Enclosure A  
L-20-071

Evaluation of the Proposed Amendment

Subject: Proposed Revision of Technical Specification (TS) 5.5.5, "Steam Generator (SG) Program" for the Beaver Valley Power Station, Unit No. 2

Figure 1 - Alloy 800 Tubesheet Sleeve - Location of Nickel Band

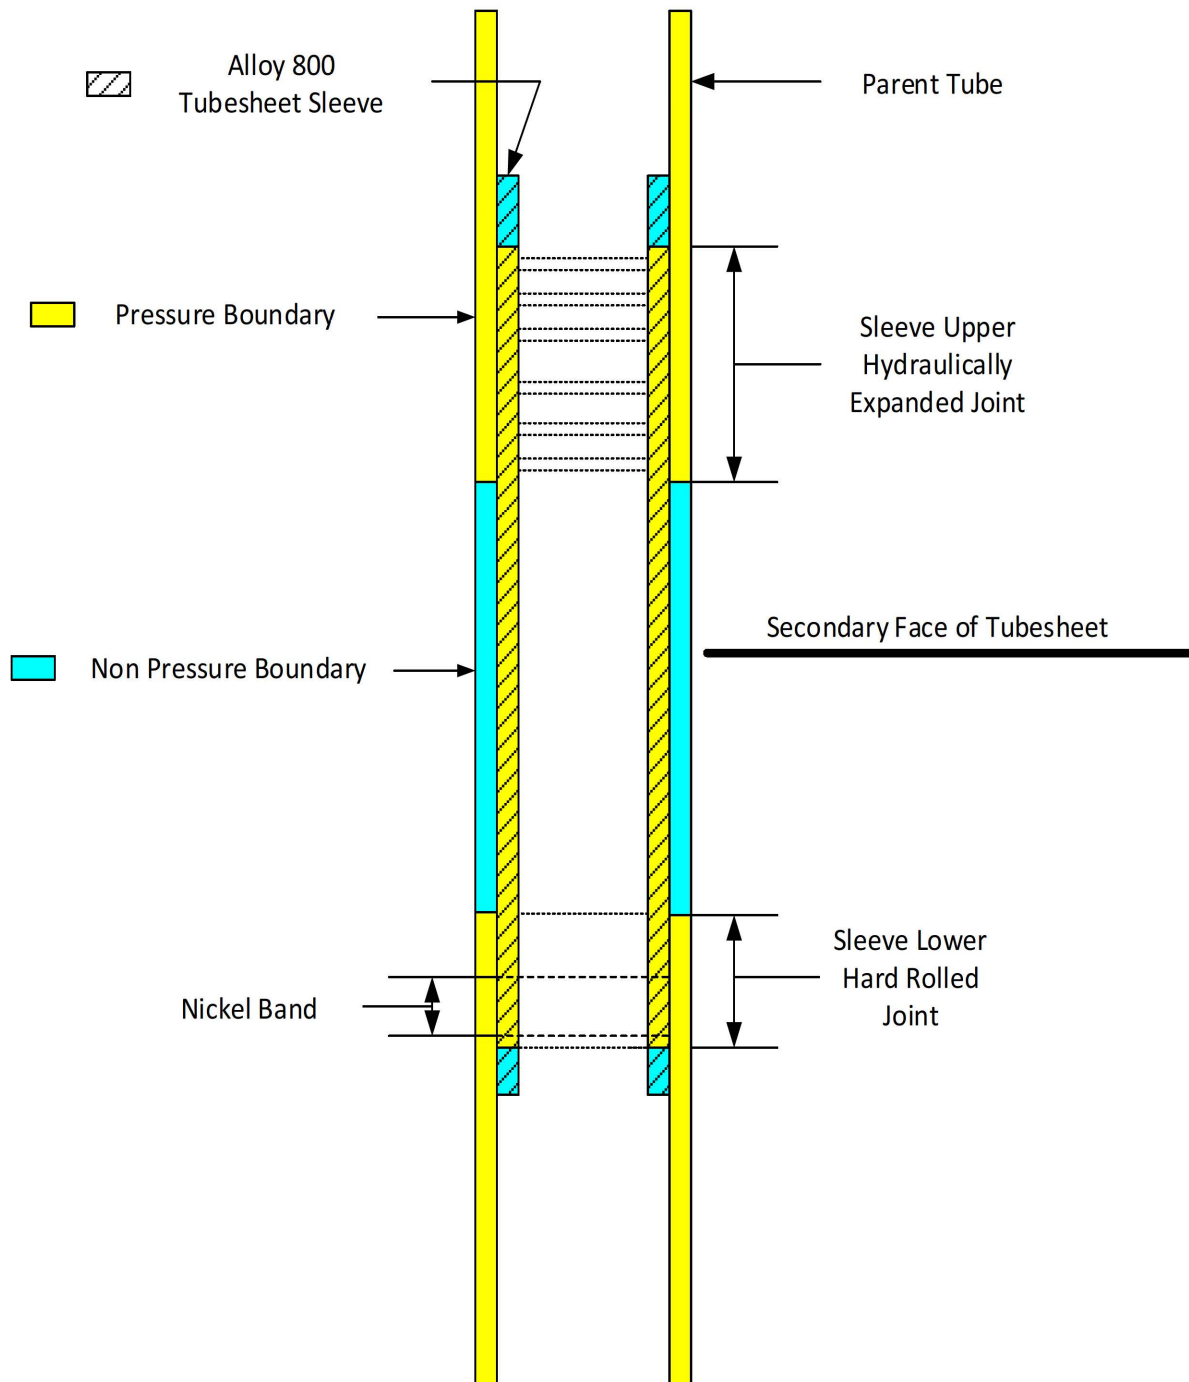
rolled against the tubesheet, and the upper portion of the sleeve is hydraulically expanded into the free-span portion of the tube above the tubesheet. The stress corrosion cracking degradation falls between the two expansion regions, so the sleeve effectively becomes the new pressure boundary and eliminates the degraded area as a concern. Figure 1 demonstrates this concept.

The Alloy 800 tubesheet sleeves used at BVPS-2 include a nickel band, applied 360 degrees around the outside diameter of the lower end of the sleeve where the hard roll is located. The nickel band is intended to improve the sealing characteristics of the lower joint.

The proposed deletion of the note located at the beginning of TS 5.5.5.2.d would remove the requirement to use the Plus point probe to inspect the portion of the original tube wall adjacent to the nickel band region of the Alloy 800 tubesheet sleeve. Deleting this note would also allow the use of an alternative inspection method (utilizing the Ghent Version 2 probe) that would ensure the SG tube integrity is maintained until the next SG inspection as required by TS 5.5.5.2.d.

The proposed change would also delete the eight fuel cycles of operation service life restriction in TS 5.5.5.2.f.3. The Ghent Version 2 probe has been site qualified to inspect the nickel band region of the Alloy 800 tubesheet sleeve and has adequately demonstrated the capability to detect axial and circumferential flaws in this region of the sleeve and original tube wall. As such, there is no need for a service life restriction on the Alloy 800 tubesheet sleeve.

Westinghouse leak-limiting Alloy 800 sleeves, WCAP-15919-P, Revision 2.
